**CITY OF BEAUFORT
DESIGN REVIEW BOARD
Staff Report
Meeting of March 10, 2016**

Case Number: 16-04 DRB.1
Project: 9 Sam's Point Road
Property Address: Parris Island Gateway & County Shed Road
Parcel #: R123 015 000 0160 0605 (a portion of this parcel)
Zoning: General Commercial
Design District: Sam's Point Road Design District
Type of Review: Preliminary Review – New Construction

The applicant is requesting to construct a new 3,500 square foot auto spa (car wash). The project is located on 1 acre on the west side of Sam's Point Road.

TREE LOCATIONS

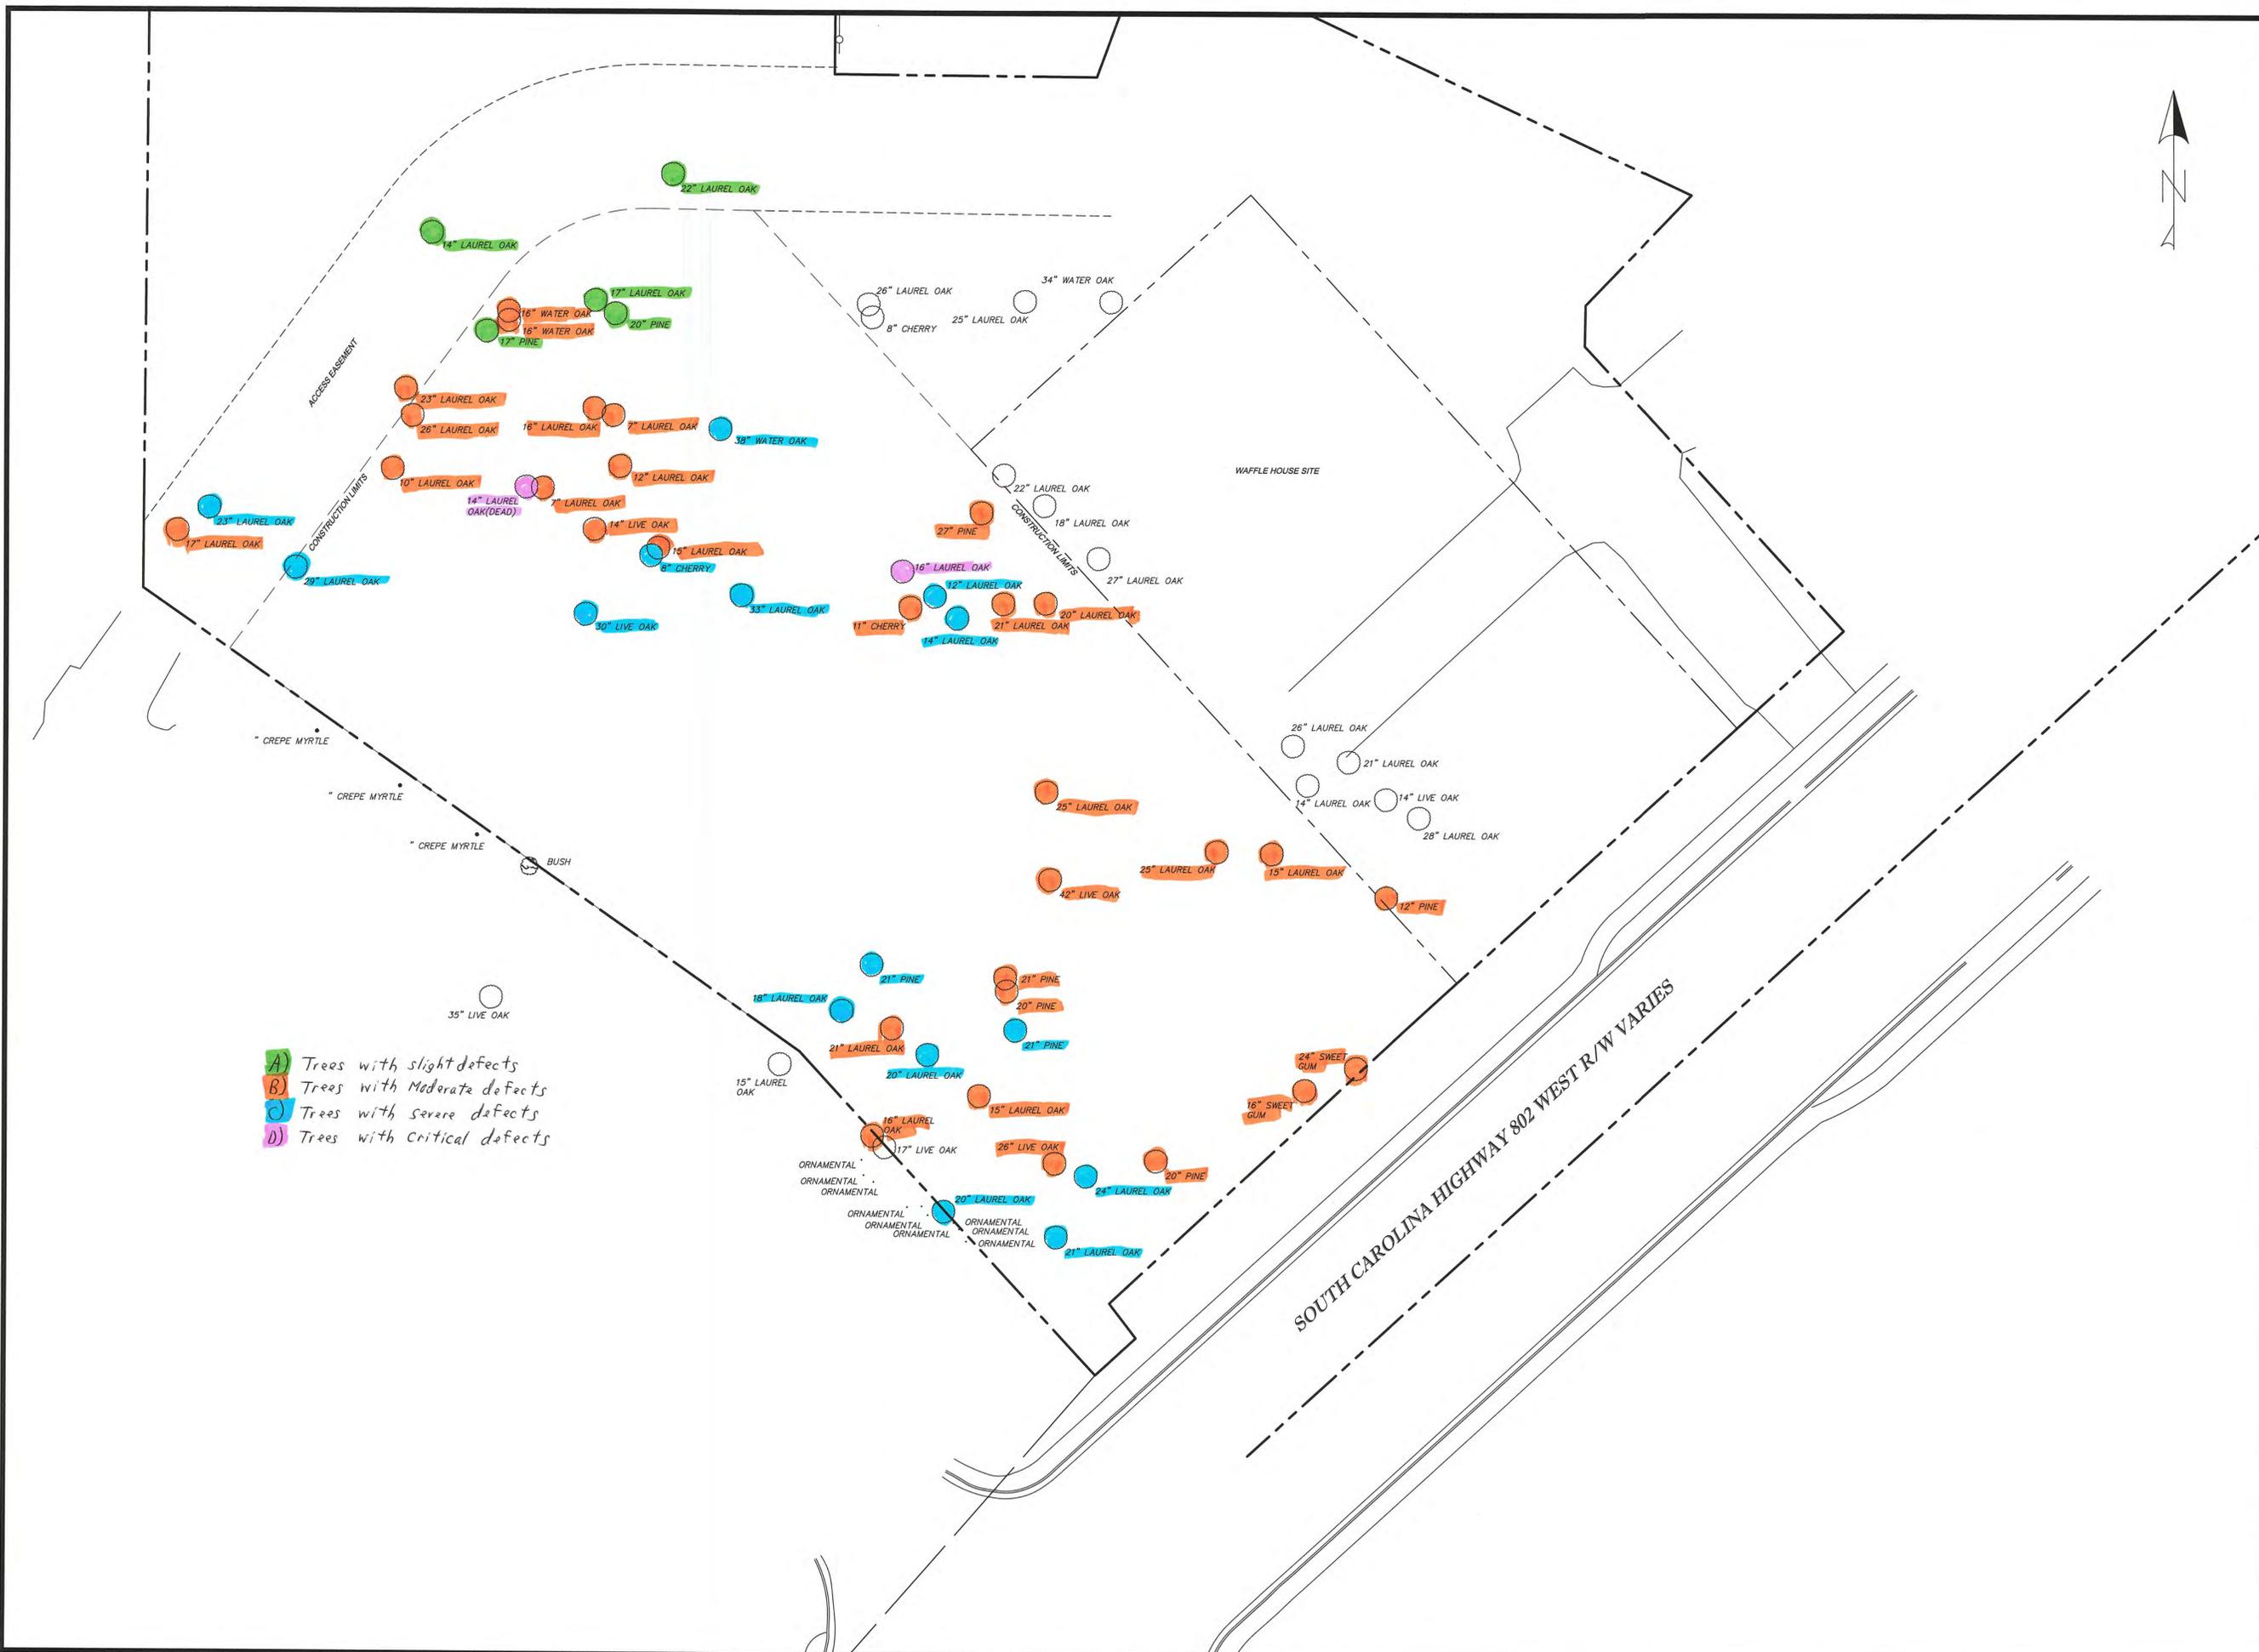
- A.) Trees with slight defects having an improbable likelihood of failure and are highlighted in Green on the site plan: 22"laurel oak, 20"pine, 17"laurel oak, 17"pine, 14"Laurel oak.

- B.) Trees with moderate defects having a possible likelihood of failure and are highlighted in Orange on the site plan: 42"live oak, 26"live oak, 27"pine, 26"laurel oak, 25"laurel oak, 25"laurel oak, 24"sweetgum, 23"laurel oak, 21"laurel oak, 21"laurel oak , 20"laurel oak, 21"pine, 20"pine, 20"pine, 17"laurel oak, 16"/16"water oak, 16"laurel oak, 16"sweetgum, 16"laurel oak, 15"laurel oak, 15"laurel oak, 15"laurel oak, 14"live oak, 12"pine, 12"laurel oak, 11"cherry, 10"laurel oak, 7"laurel oak, 7"laurel oak.

- C.) Trees with severe defects having a probable likelihood of failure and are highlighted in Blue on the site plan: 38"water oak, 33"laurel oak, 30"live oak, 29"laurel oak, 24"laurel oak, 23"laurel oak, 21"laurel oak, 21"pine, 21"pine, 20"laurel oak, 20"laurel oak, 18"laurel oak, 17"live oak, 14"laurel oak, 12"laurel oak, 8"cherry.

- D.) Trees with critical defects having an imminent likelihood of failure and are highlighted in Red on the site plan: 16"laurel oak, 14"laurel oak.
